Stormwater Management System Report

Addendum 1

SHELL POINT PLACE

PROPOSED DEFINITIVE SUBDIVISION PLAN

POST DEVELOPMENT WATERSHED PLAN

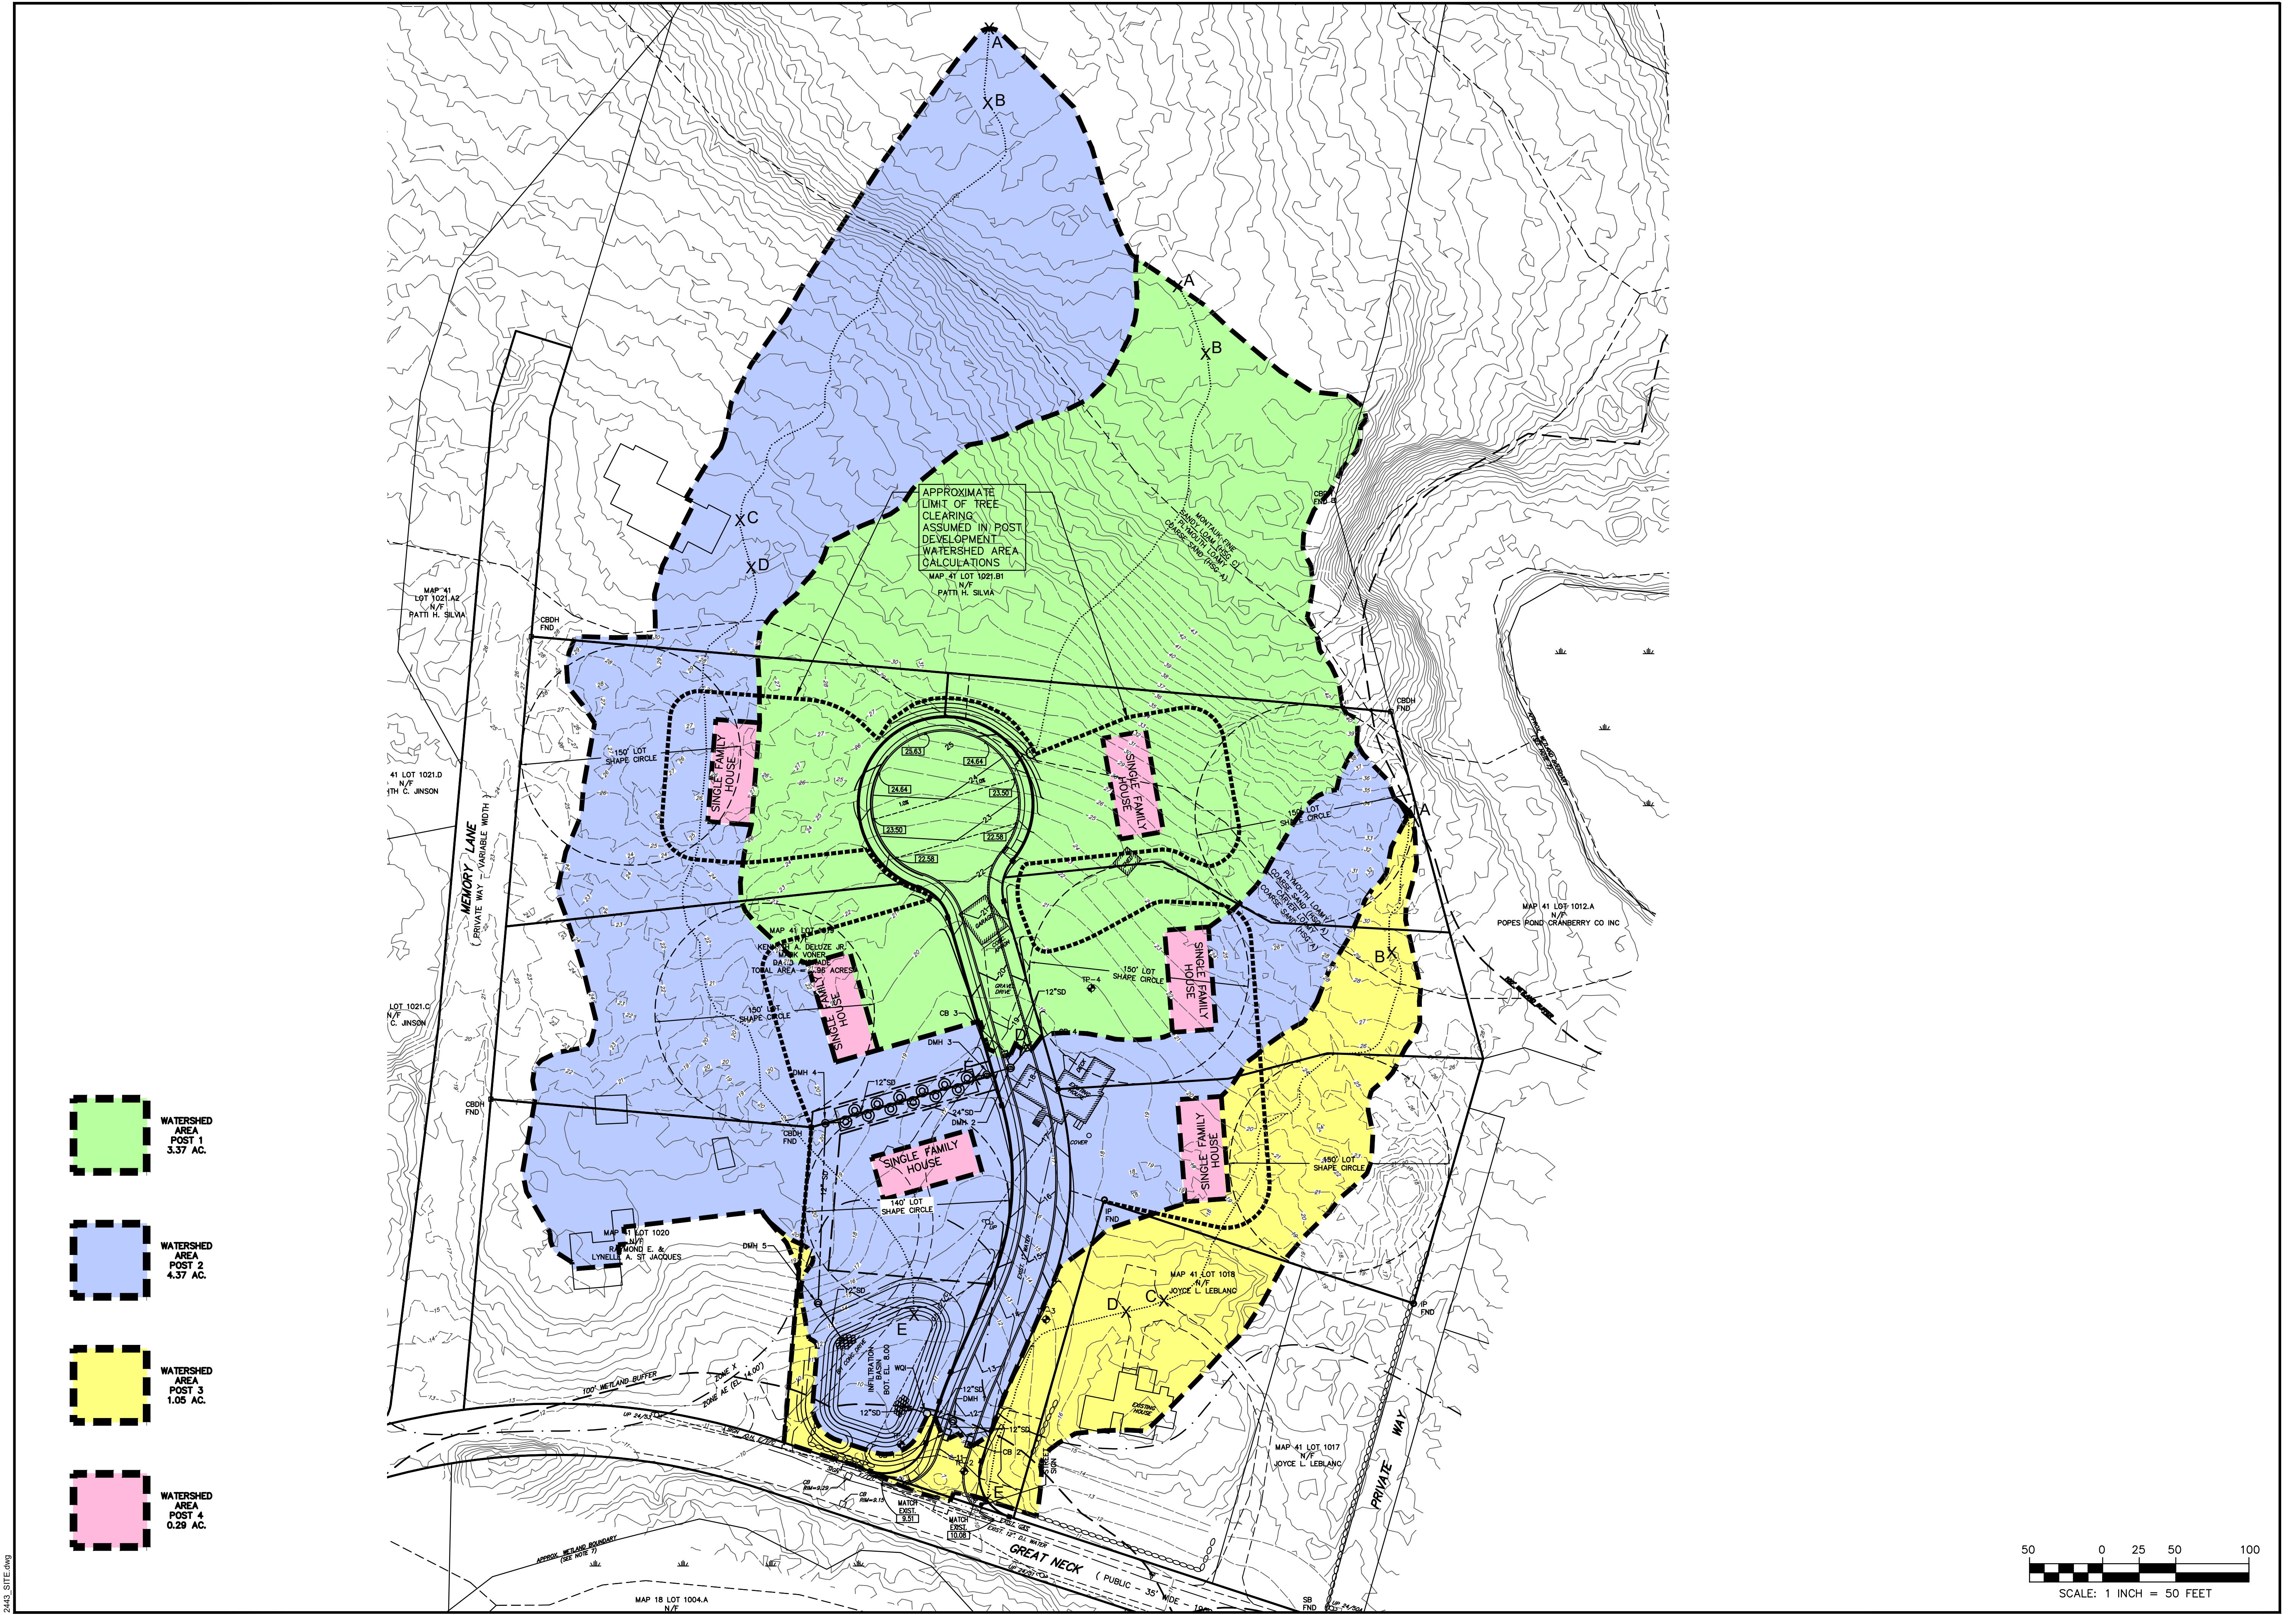
- Revised Design of "Upper Drainage System" of leaching pits.
- Presentation of Revised Post Development Hydrologic Calculations incorporating revised leaching pit design and clarifying breakdown of subcatchment areas.
- Updated Post Development Watershed Plan

As mentioned above, the post development hydrologic calculations have been reviewed and revised to address comments made by the Planning Board's peer review consultant. We have reviewed and revised the subcatchment area land cover type breakdown to clarify the allotments of impervious area associated with the roadway, sidewalks, and driveways. We have also revised the calculations to incorporate the revised design of the "Upper Drainage System" with an increased number of leaching pits to maximize the retention of runoff up through the 25-year storm event.
